APPLICATION NO: 13/05616/P Outline Planning
EXPIRY DATE: 16 May 2014

Hybrid outline application for demolition of existing buildings on the site and phased redevelopment of site, comprising full application for Phase 1 and outline application for Phase 2. Full details provided for Phase 1 comprising: up to 45 residential units in a ground plus 8 storeys building, with up to 401.9 sq m GIA of flexible commercial floorspace (falling within Use Classes A1 - A5, B1 and D1) at ground floor level and associated space, cycle storage, refuse storage, plant, servicing, ancillary storage, public realm at lower ground floor and ground floor level. Outline details for Phase 2 to comprise up to 143 residential units in a building up to ground plus 15 storeys in height and 203.5 sq m GIA of flexible commercial floorspace (falling within Use Classes A1 - A5, B1 and D1) at ground floor level and associated space for parking, cycle parking, refuse storage, plant, servicing, ancillary storage lower ground floor and ground floor level. Details of access, scale and layout to be determined at the outline stage with details of appearance and landscaping to be determined in Reserved Matters applications

Drawing Title
Ground Floor Layout

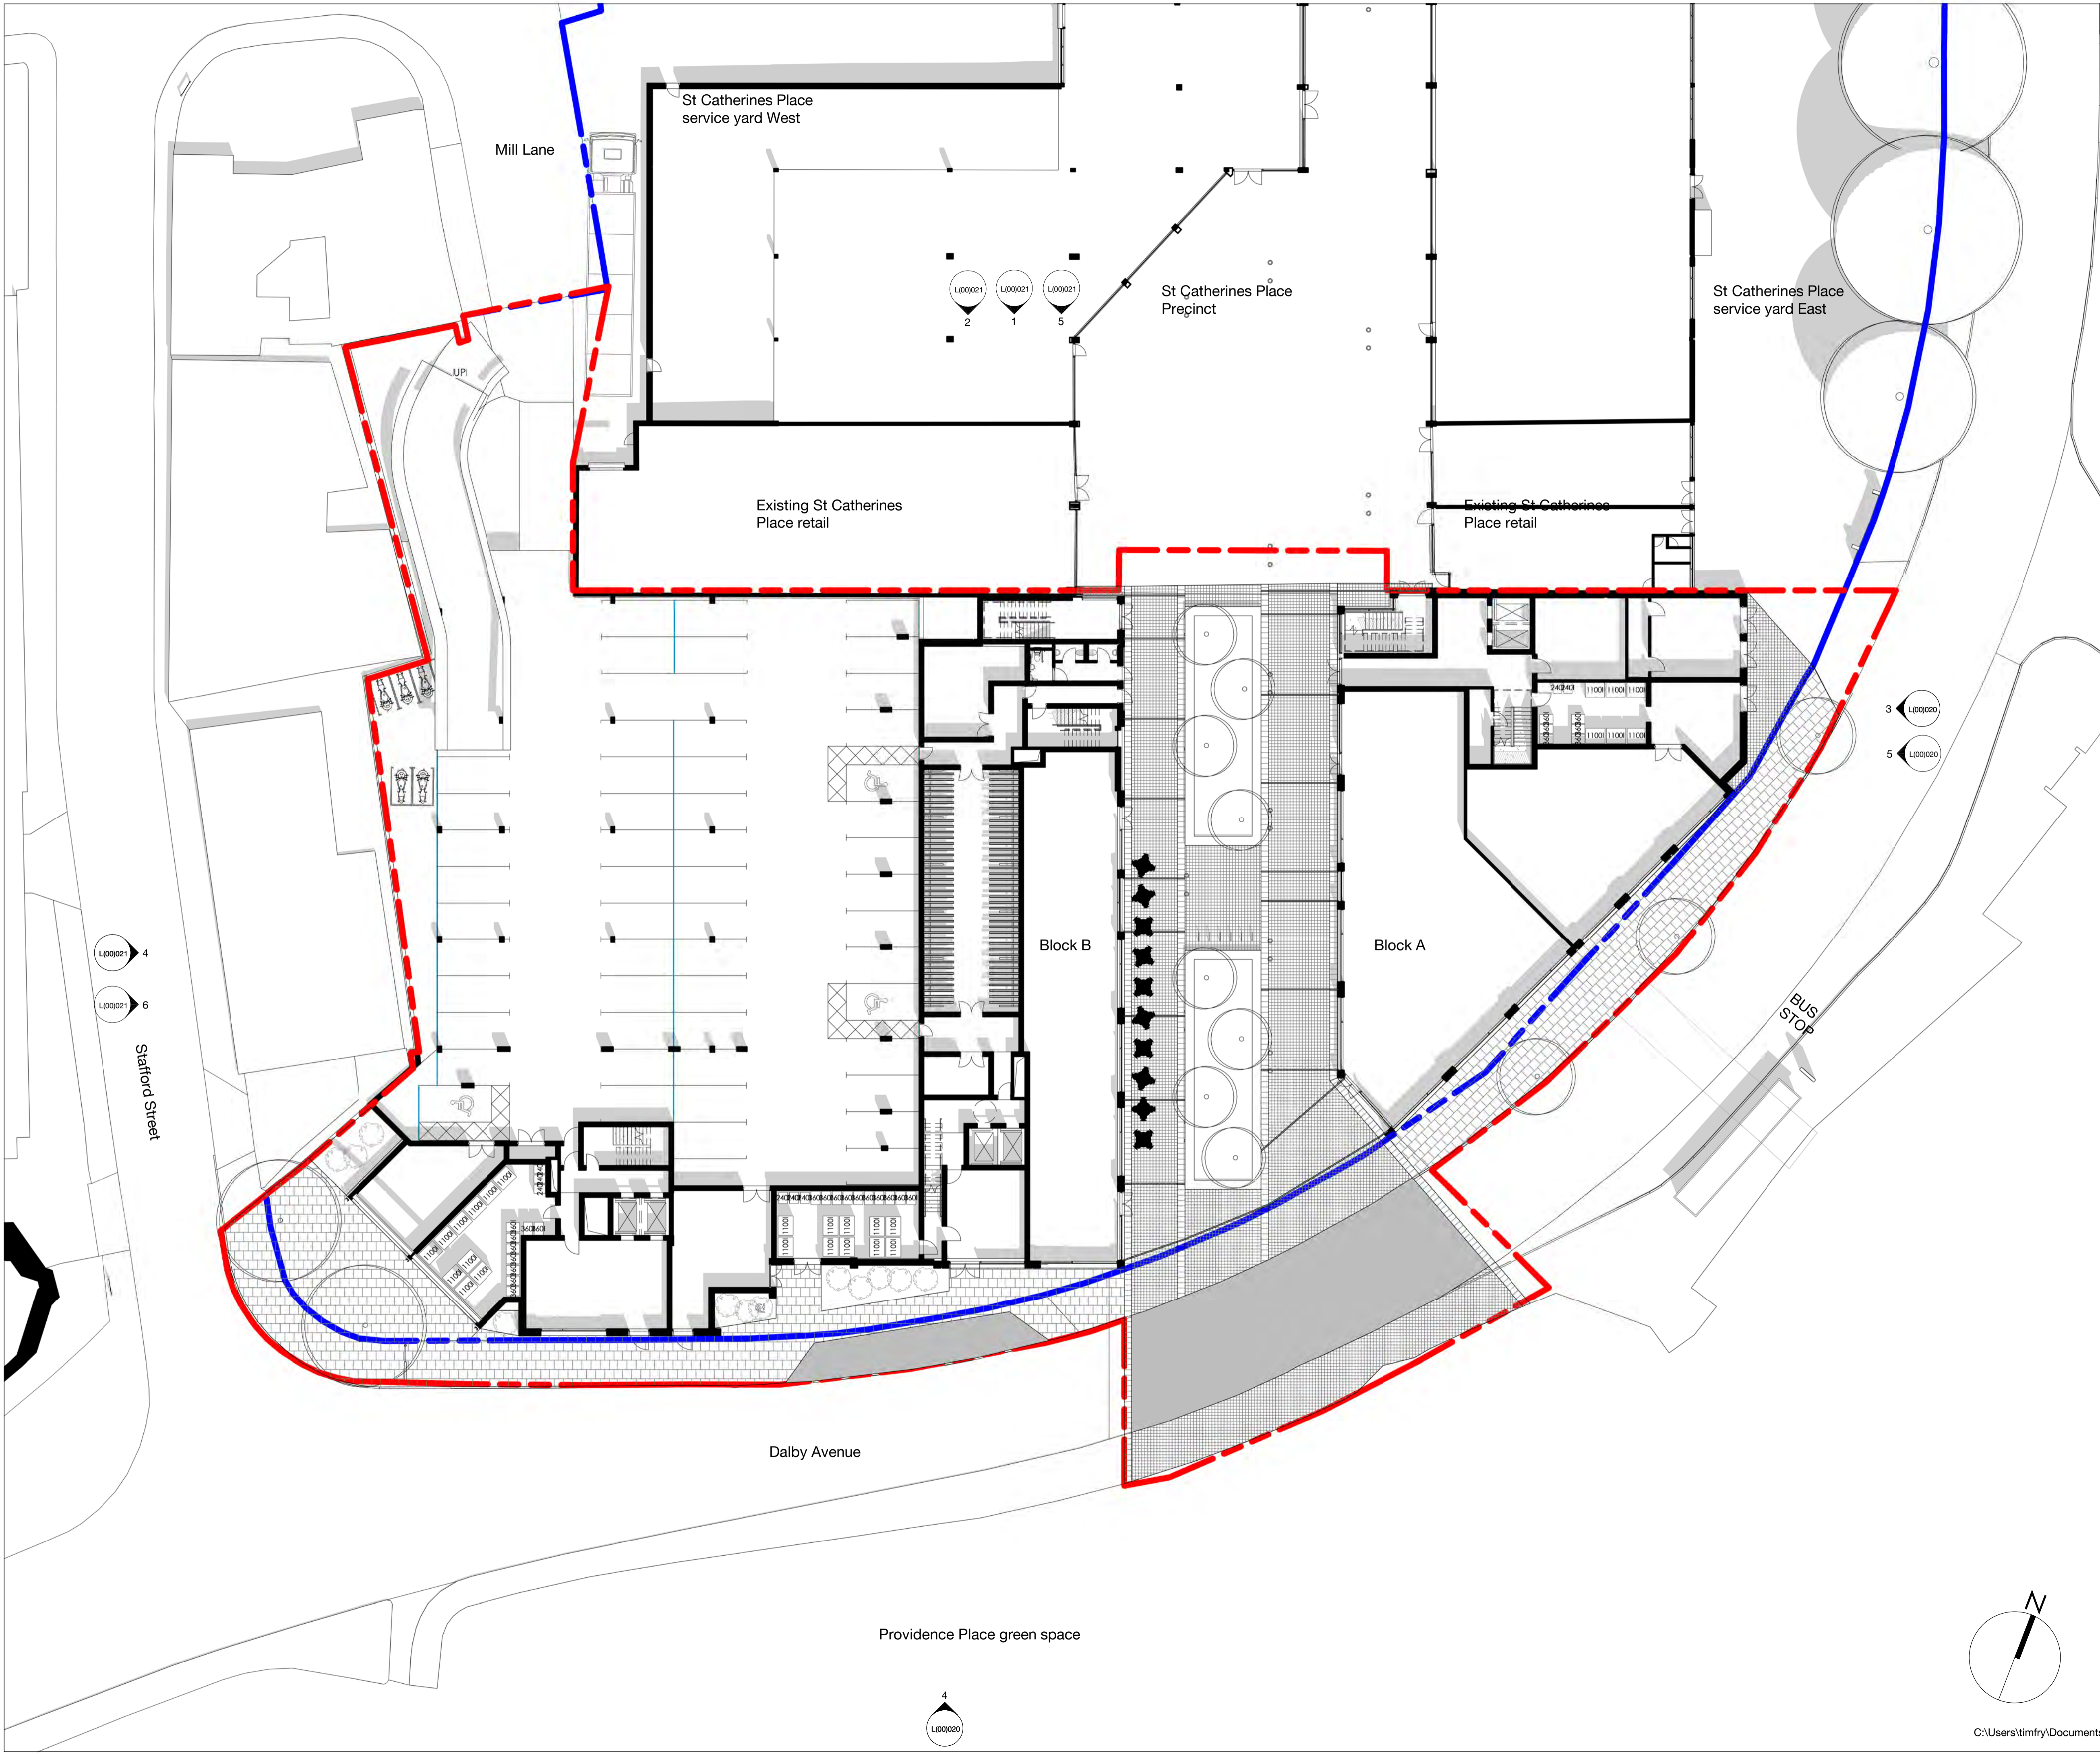
J	Block B raised 1800mm	TF	23/06/14
I	Planning	TF	16.12.13
H	Pre planning issue	TF	28.11.13
G	issue to hydroc	TF	18/11/13
F	General update	DR	06.08.13
E	updated to comments	DR	12.09.12
D	service and carparking revised	DR	07.09.12
C	updated to comments	DR	23.08.12
B	design development	DR	07.08.12
A	Large retail unit amended to 4500sqft	RG	06.07.12
